SOUTHERN ENVIRONMENTAL LAW CENTER

RE: Concerns Regarding the U.S. Department of Energy's Recent Actions During the U.S. Environmental Protection Agency's Review of the December 31, 2020 Radionuclide Pollution Decision for the Oak Ridge Reservation Facility in Oak Ridge, Tennessee

Figure 1. Site Characterization: Groundwater Levels.[17]

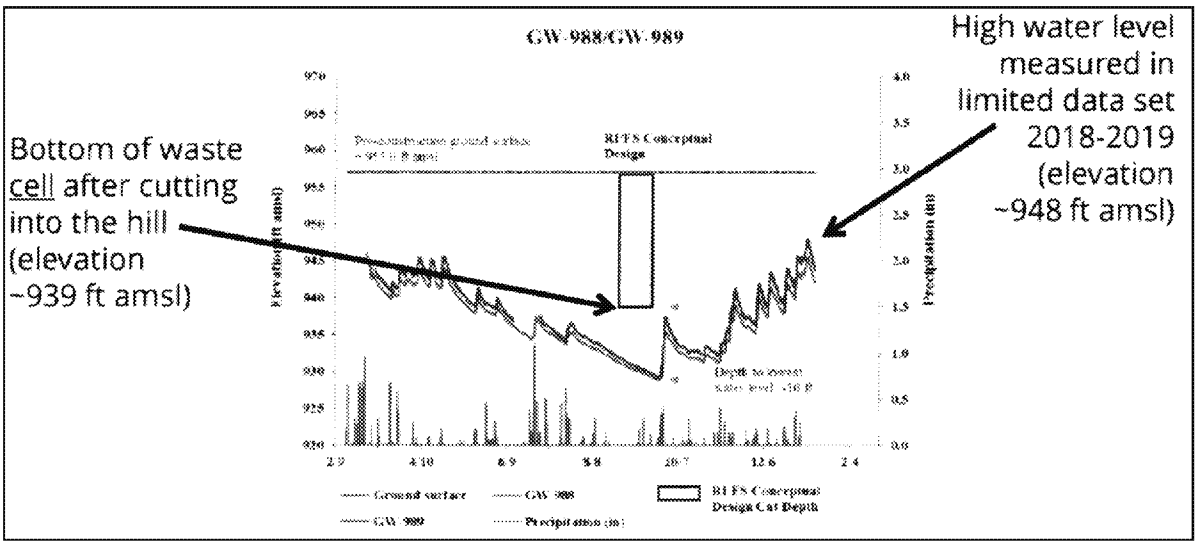
New groundwater information significantly changes the features of the remedy the Department has proposed: to construct a landfill that would taint a greenfield on the Oak Ridge Reservation (the Proposed Plan).[11] In the Proposed Plan, the Department claimed the location was the "most appropriate area on the [Oak Ridge Reservation] for locating an onsite disposal facility" in part due to its "groundwater flow conditions," citing the "considerable amount of information" available about the subsurface and groundwater conditions in Bear Creek Valley.[12] At the time of the public comment period, the Department told the public that the landfill would maintain a "10 ft geologic buffer above seasonal high groundwater."[13] The Department said that "[r]esults of the Phase 1 site characterization confirm the acceptability of the [landfill] site for a new, low-level waste landfill and support final site selection."[14] However, recently released Technical Memorandum 2 reveals that groundwater levels at the site are significantly higher than originally anticipated and understood.[15] According to the new groundwater information, a substantial portion of the landfill would sit below the water table.[16] (Figure 1).

The newly revealed groundwater levels at Bear Creek Valley raise critical questions about the design and performance of the landfill as proposed. The U.S. Environmental Protection Agency's (EPA) comments on Technical Memorandum 2 underline that the proposed landfill must have "a completely unsaturated clay geobuffer layer to demonstrate the protectiveness requirements necessary to obtain waivers."[18] However, the landfill as proposed would sit below the water table, and there is a substantial risk that waste would not be adequately contained.[19] The Tennessee Department of Environment (TDEC) stated that Technical Memorandum 2 "raises significant questions about how [the Department] will support the contention that the [proposed landfill] site is acceptable."[20] More explicitly, TDEC stated that Technical Memorandum 2 "makes it difficult to determine if the landfill can be constructed and operated in a manner that will meet the two CERCLA threshold criteria."[21] In the wake of this new information, the Department has not altered the Proposed Plan or given the public an opportunity to comment on the issues raised by this new information.
